Rochester Gas and Electric Corporation  
(R. E. Ginna Nuclear Power Plant,  
Unit No. 1)

Docket No. 50-244

APPLICATION FOR AMENDMENT  
TO OPERATING LICENSE

Safeguards Bus Voltage

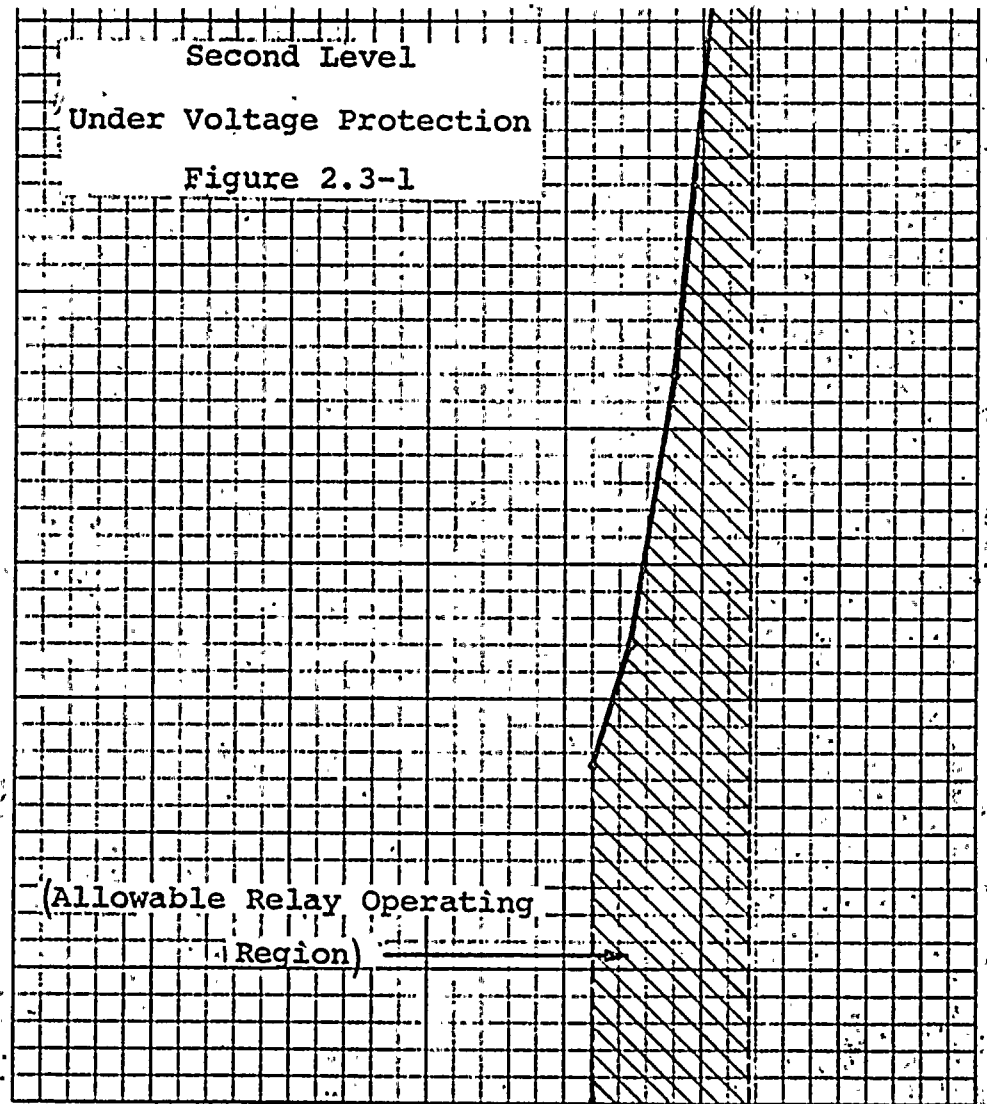
2.3.3.2 Acceptable degraded voltage relay operating times and setpoints, for 480 volt safeguards bus voltages  $\leq 414$  volts and  $\geq 368$  volts are defined by the safeguard equipment thermal capability curve shown in Figure 2.3-1.

The loss of voltage and degraded voltage trips ensure operability of safeguards equipment during a postulated design basis event concurrent with a degraded bus voltage condition. (9)(10)(11)
